ADDENDUM NO. 1
to
CONTRACT DOCUMENTS

for
HVAC RENOVATIONS TO PRINCETON HIGH SCHOOL
located at 151 Moore Street, Princeton, NJ 08540

FVHD PROJECT NO. 5516E

Issued: February 24, 2026

6 FLUE BRACKET @ FLOOR LEVEL DETAIL
1" = 1'-0"

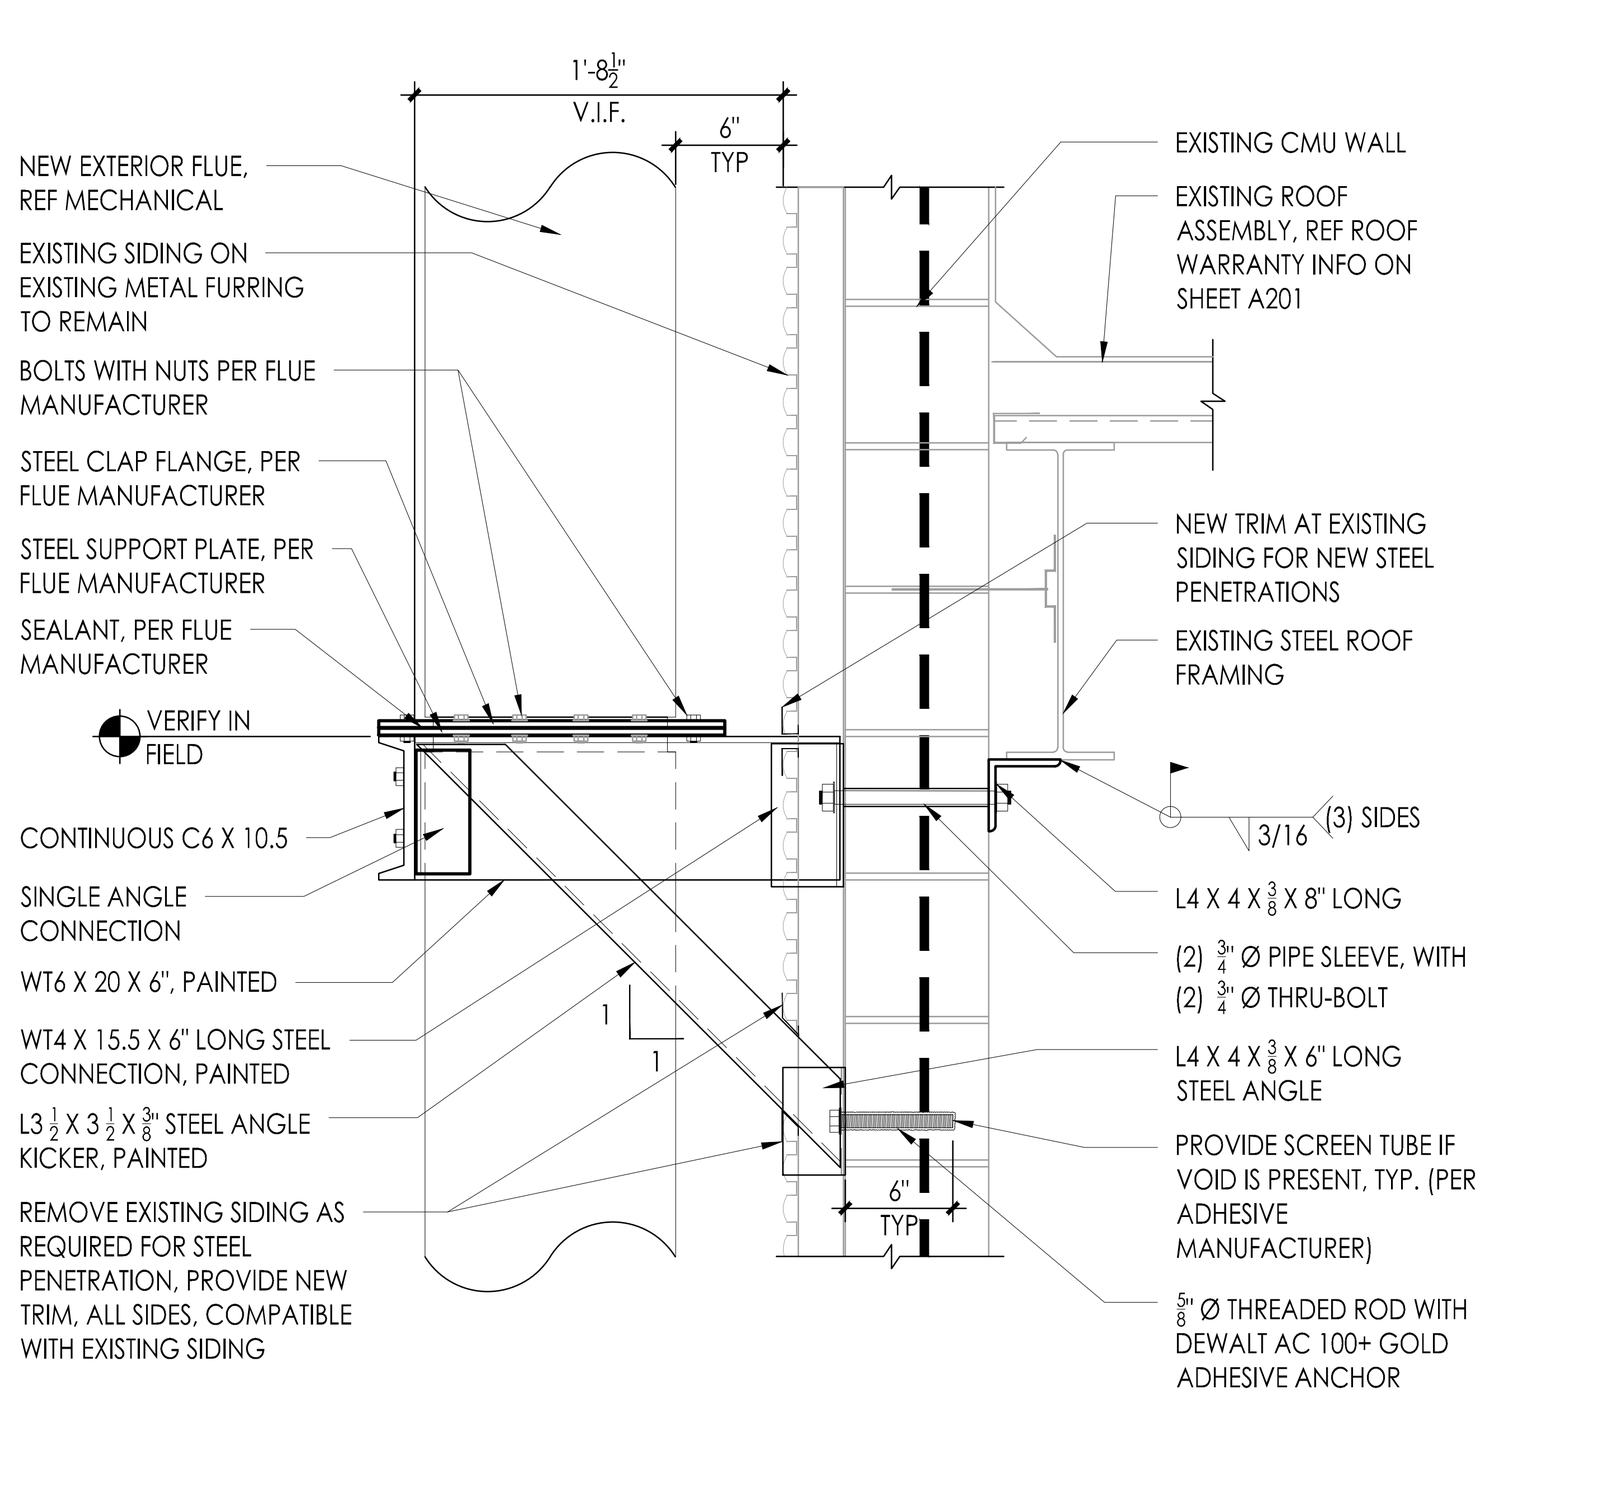
5. Question: On Drawing A201, Notes (3)- 9 times, (4) - 1 time, and (10) -5 times, all refer to 11/A201, there is no 11 / A201, please advise. Also are we to assume (1) angle frame per occurrence?

Response: 10/A201 should be 6/A201, and 11/A201 should be 4/A201. (Refer to the updated Drawing). The steel angle RTU support size is referenced in the steel notes on Detail 6/A201.

Drawing Number
M-701

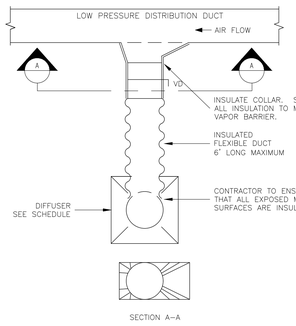
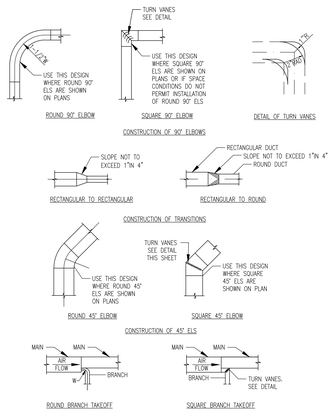
3. Question: Is EF-E9, shown as Alternate #2 on the schedule, a replacement of EF-E9 as shown on M-435?

There is a reference for the new exhaust fan (EF-E9) on Drawing (M-701) that showed Alt #2. This Drawing has been revised to show Alt #1. The installation of the new fan is shown on Drawing M-435-1.

Exhaust fan EF-E9 is being replaced under Alt #1, not Alt #2. The mechanical schedule Drawing (M-701) was revised to reflect Alt #1. The replacement of this fan is shown on Drawing M-435-1. The scope of work on Drawing M-435 pertains to the base bid in which EF-E9 is only being rebalanced.

Drawing Number
M-901

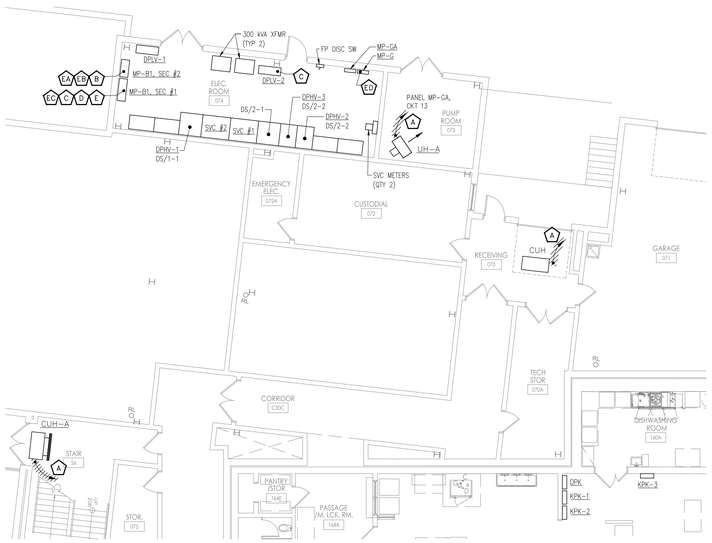
8. Question: Please provide Sequence of Operations Drawings M-06, M-07, M-08, as mentioned on Drawing M-901 Item A (Control System Performance Specification).

Response: The reference to M-06 thru M-08 is a mistake. The Control Drawings and Sequences of Operation are found on M-600 thru M612.

Drawing Number
ED-502

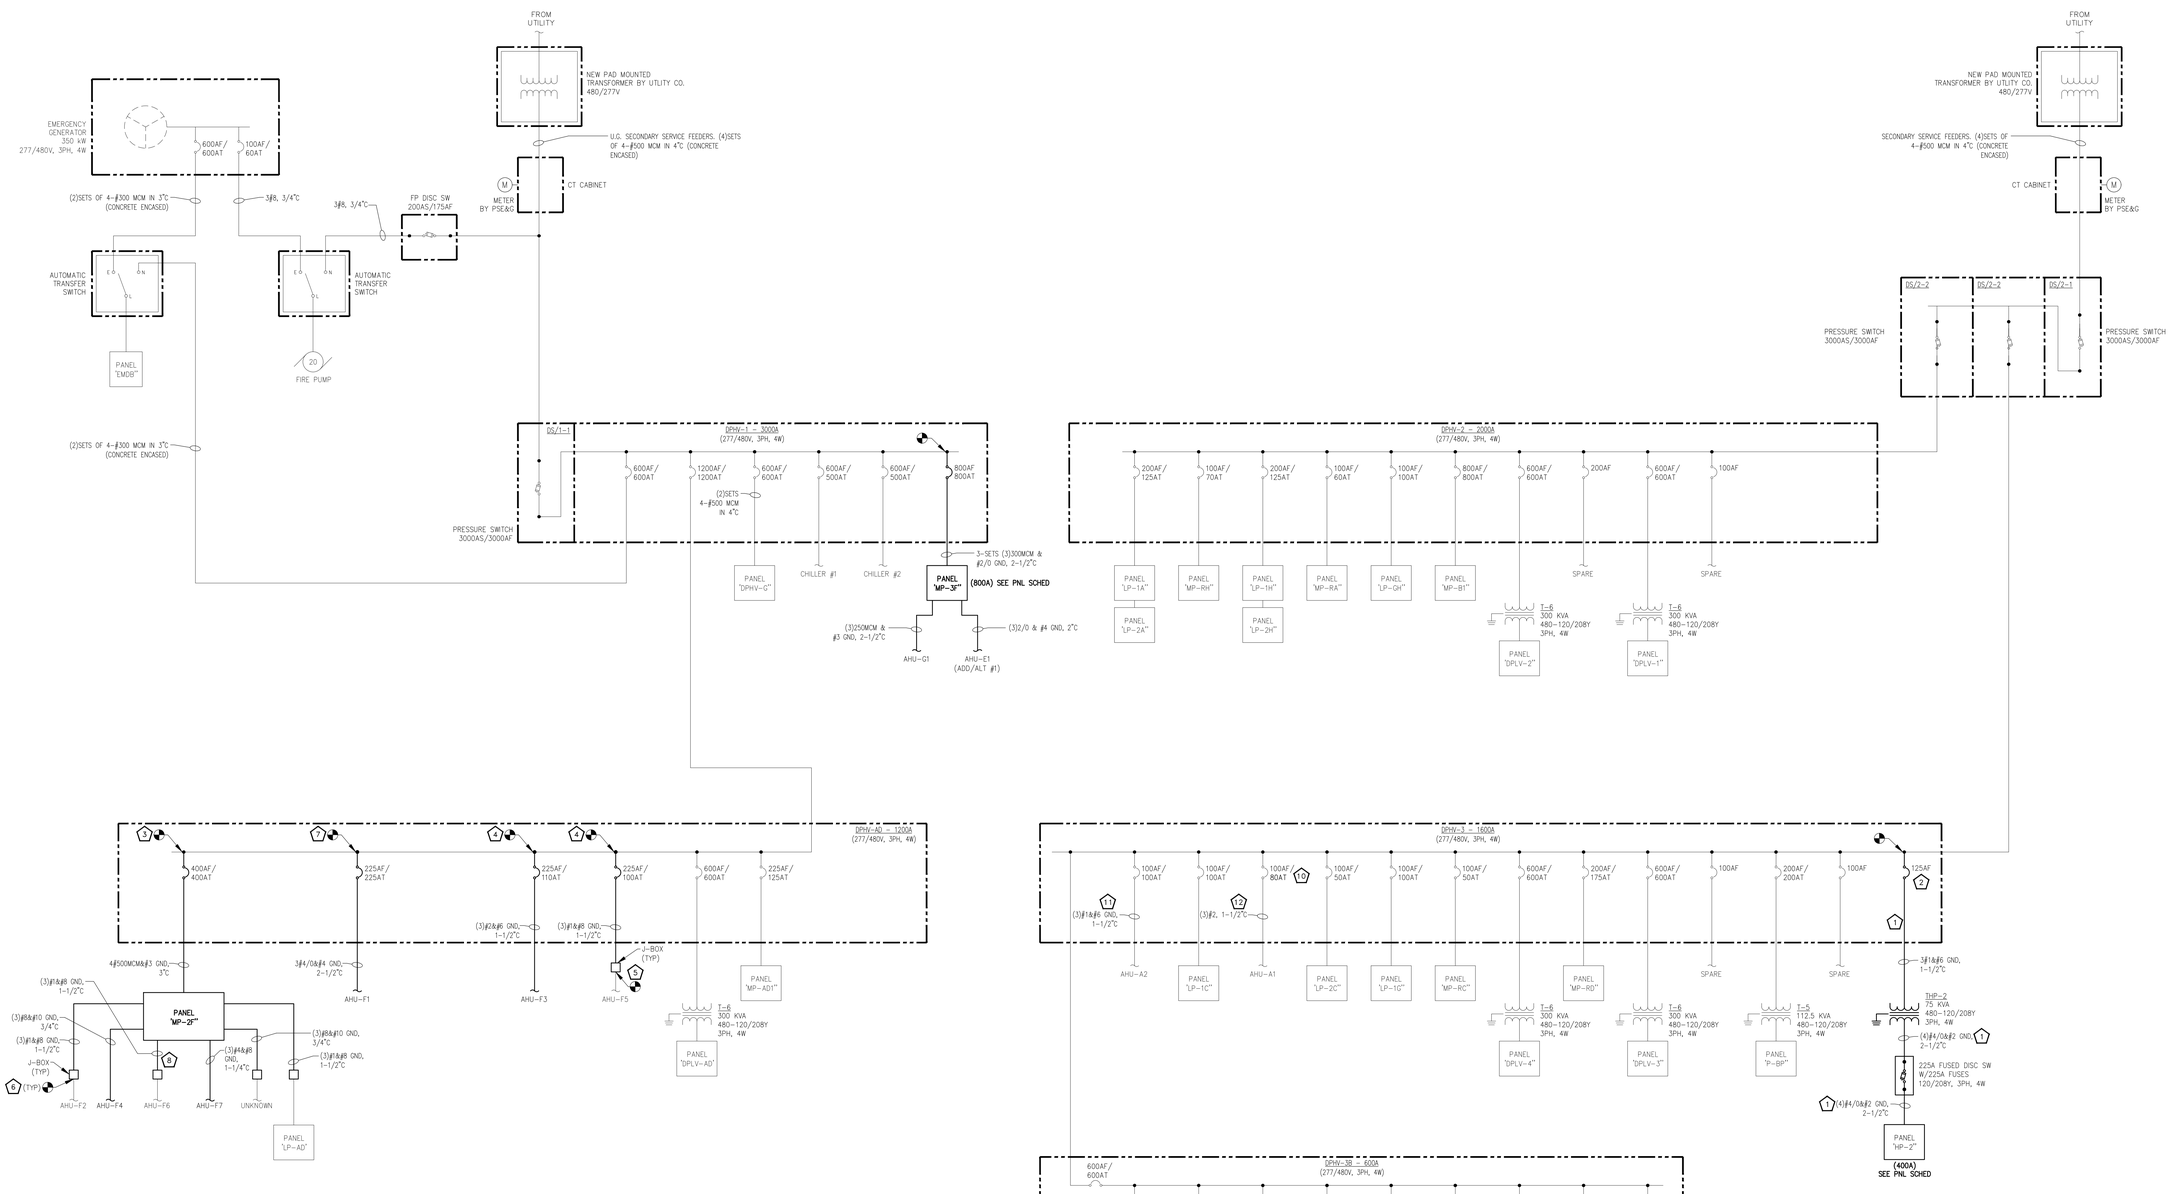
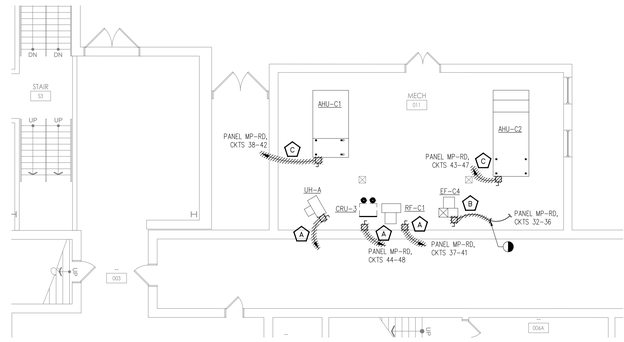
15. Question: On Drawing ED-502 Detail 1, Note ED is missing. Please Advise.

Response: Note on ED-502 has been added to remove conductors from breaker (ckt 79) for DWH control circuit and label breaker as 'spare'.
